**DRAFT FINAL SUMMARY AND  
TECHNICAL EVALUATION REVIEW  
OF WORK PERFORMED AT 51  
SWMUs AND AOCs  
U.S. NAVAL STATION  
ROOSEVELT ROADS  
CEIBA, PUERTO RICO  
Work Assignment: R02031  
(Ref. No. 1-635-340)**

**Prepared for:  
U.S. Environmental Protection Agency**

Work Assignment No.:	R02031
EPA Region:	II
EPA Site/Facility I.D. No.:	PR2170027203
Contract No.:	68-W9-0003 (TES-6)
TRC Document No.:	NY-R31.RP4
TRC Project No.:	1-635-340-3-2000-0
TRC Project Manager:	Steven E. Panter
Telephone Number:	(908) 563-1100
Subcontract No.:	NA
Subcontractor Project Manager:	NA
Telephone No.:	NA
EPA Work Assignment Manager:	Timothy Gordon
Telephone No.:	(212) 264-9538
Date Prepared:	June 30, 1993

Sketch of Site:

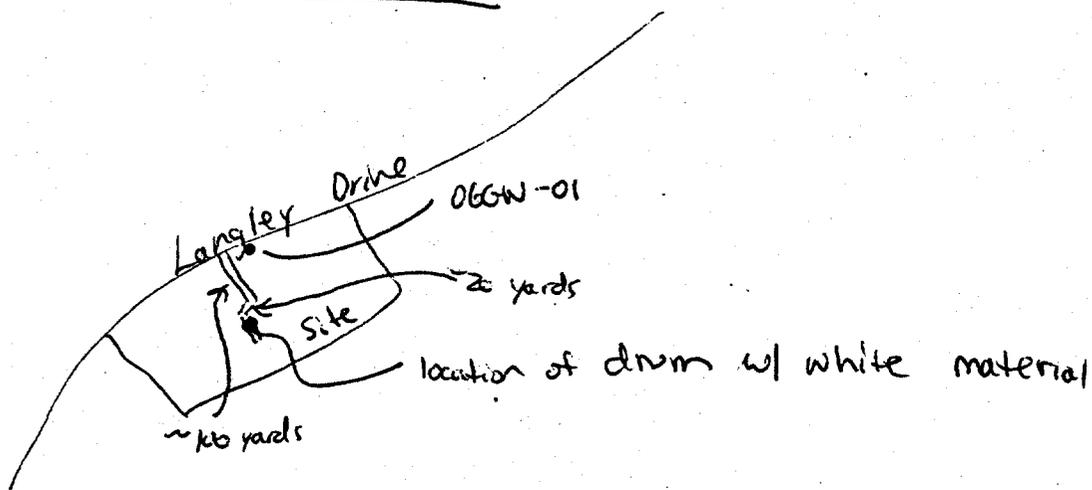
1. Sample the white material of the drum to determine if they are hazardous or not.

2. The vegetative growth on the site is so thick that it is virtually impenetrable w/out the aid of a backhoe/bulldozer.
3. Other materials observed included rusted metal flexible pipe & concrete debris.
4. Baker's results should be in shortly obtain copy to make suggestions.

Location of storm drain:

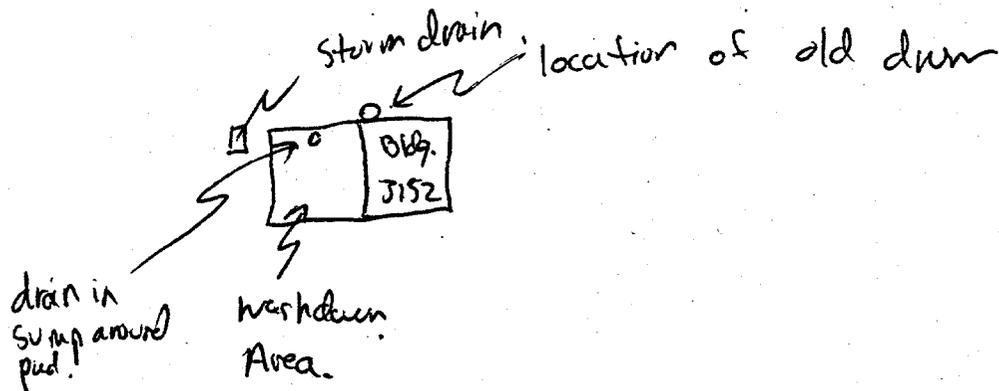
1. May want to collect samples ~~around~~ in storm drain to check for release.

Sketch:

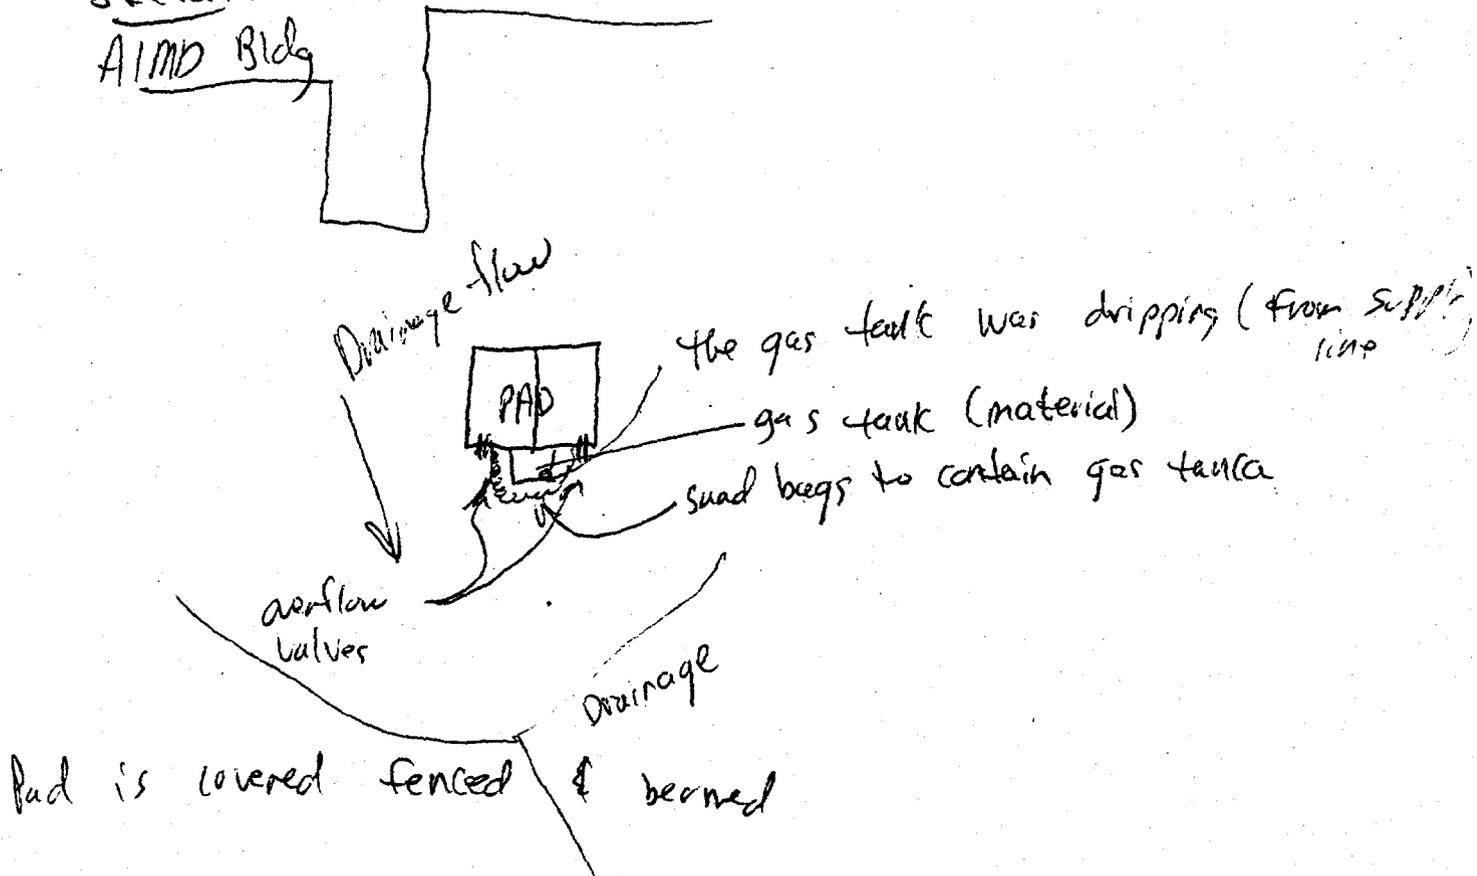
10.
  1. Recommend sampling of drainage ditches to check for impact on drainage ditches
  2. Pad should be cleared so that any overflows don't contain waste.
